# Access Compliance Report

## Public Rights-of-Way

Intersection ID: 2550	Main Street: ABBOTTSGATE_LN	Cross Street: WHITEGATE_LN	Location:	W
ADA ID: 96118981C5AB	Ramp Type: Perp	Initial Pass/Fail: Fail	Overall Compliance: No	Severity Score: 12.5
Codes/Mitigation Info/Possible Solution		Field Measurements/Component Compliance

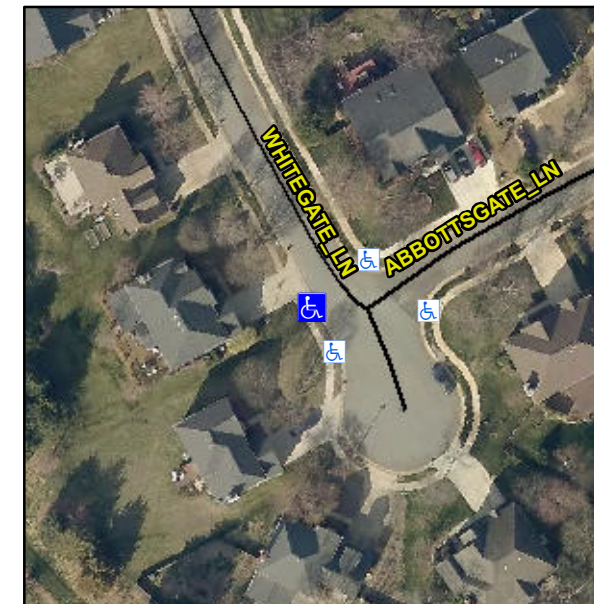
**Remove & Replace Entire Ramp.**

**Not Found, R304.2.2**

Compliance	Description	Data	Compliance	Description	Data
N/A	Ramp Length (in)	46.0	No	Ramp Slope (%)	9.7
Yes	Ramp Width (in)	48.0	Yes	Ramp XSlope (%)	0.3
N/A	Flare Type LT	N/A	N/A	Flare Type RT	N/A
N/A	Flare Slope LT (%)	N/A	N/A	Flare Slope RT (%)	N/A
N/A	Flare Traversable LT?	N/A	N/A	Flare Traversable RT?	N/A
N/A	Landing Length (in)	N/A	N/A	DWS Provided?	N/A
N/A	Landing Width (in)	N/A	N/A	DWS Contrast?	N/A
N/A	Landing Slope (%)	N/A	N/A	DWS Length (in)	N/A
N/A	Landing X Slope (%)	N/A	N/A	DWS Full Width?	N/A
N/A	Landing Curb? (Y/N)	N/A	N/A	DWS Offset (in)	N/A
N/A	Shared Landing?	N/A			
N/A	Gutter Ponding?	N/A	N/A	Gutter Slope (%)	N/A
N/A	Gutter Lip Ht (in)	N/A	N/A	Gutter X Slope (%)	N/A
N/A	Painted X Walk1?	No	N/A	Painted X Walk2?	N/A
	X Walk 1 Direction	To NE		X Walk 2 Direction	N/A
N/A	X Walk 1 Width (in)	N/A	N/A	X Walk 2 Width (in)	N/A
	X Walk 1 Slope (%)	2.6		X Walk 2 Slope (%)	N/A
	X Walk 1 X Slope (%)	0.5		X Walk 2 X Slope (%)	N/A
